1R - 425 - 1

From: Hansen, Edward J., EMNRD
Sent: Wednesday, March 21, 2007 3:20 PM
To: Carolyn Haynes; 'Kristin Pope'
Cc: Price, Wayne, EMNRD; 'L. Peter Galusky, Jr. P.E.'
Subject: 1R0425-01 - Vacuum SWD E-2 Site; 1R0425-03 - Vacuum SWD K-35-1; 1R0479 - Vacuum SWD N-6-1

From: Price, Wayne, EMNRD
Sent: Friday, May 19, 2006 2:11 PM
To: 'lpg@texerra.com'
Cc: Kristin Pope
Subject: RE: Rice Operating Company Vacuum Field E-2 ICP, OCD # 1R0425-01

**RE: Investigation and Characterization Plan
Vacuum E-2 Junction Box, UL E Sec 2 T18S R 35E**

Vacuum jet. E-2

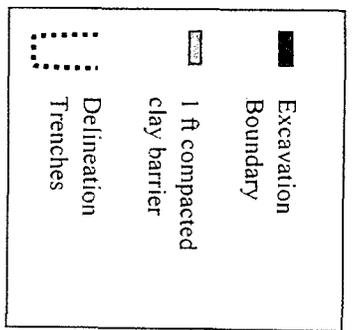
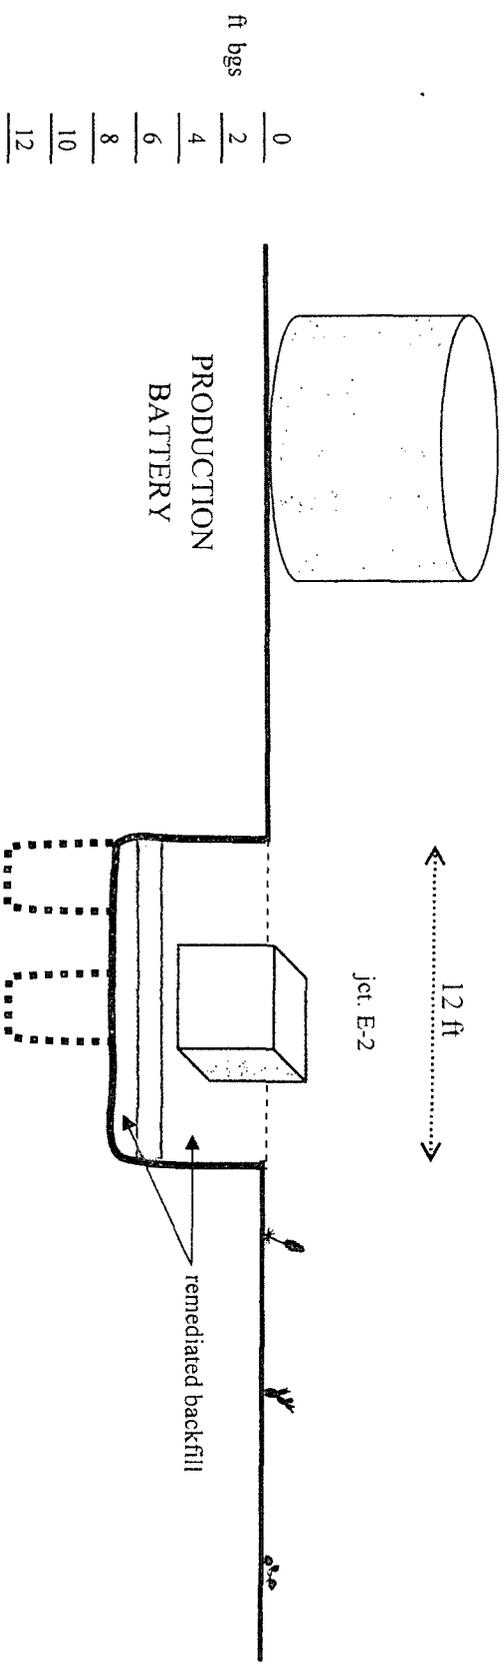
As constructed cross-sections of clay liners: Please find the attached images for each site, which were prepared b I have also included photographs to supplement the drawings.

Figure B-3 – Preliminary Chloride Data

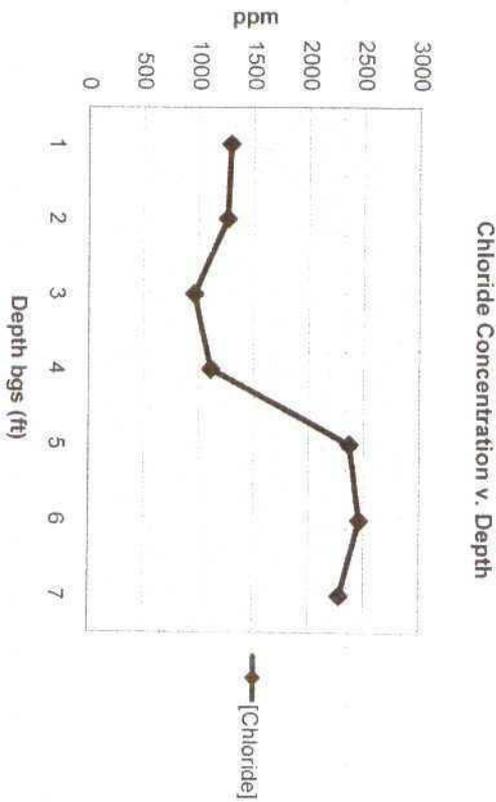
Special Note: From looking at the disclosure report it appeared that chloride levels ranged from 960-3958. If this project was closed pursuant to "in accordance with the OCD-approved Junction Box Upgrade Work Plan (Rev. July 2003)" which only allow soils containing 1000 ppm chlorides there may be an issue of proper closure. Please investigate this issue and explain why the clay barrier was placed before final investigation. Also explain why this closure did not follow the Jct Box work plan.
